OFFICE MEMORANDUM

DEPARTMENT OF STATE HIGHWAYS

Subject: Fiberglass Reinforced Pultrusions.
Research Project 75 NM-446. Research Report No. R-990.

Figure 1. Two configurations of fiberglass pultrusions.

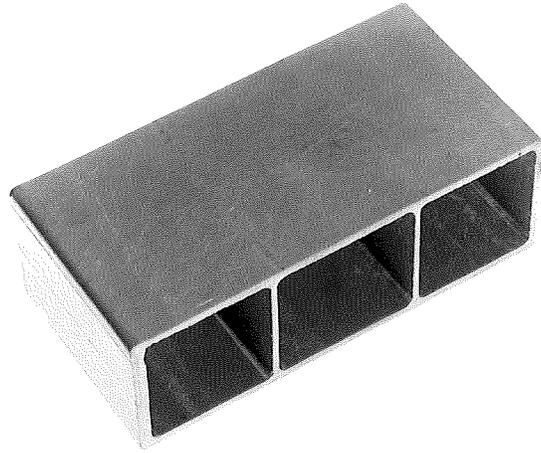
Manufacturer's literature describes fiberglass pultrusions as follows: "Pultrusion is a composite which consists of a thermosetting resin matrix and permanently bonded fiberglass reinforcement. The fibers are first pulled through the resin bath and then through a heated die, where the resin saturated fibers are polymerized. The configuration of the heated die determines the configuration of the end product." The two configurations supplied to the Department as samples are shown in Figure 1.
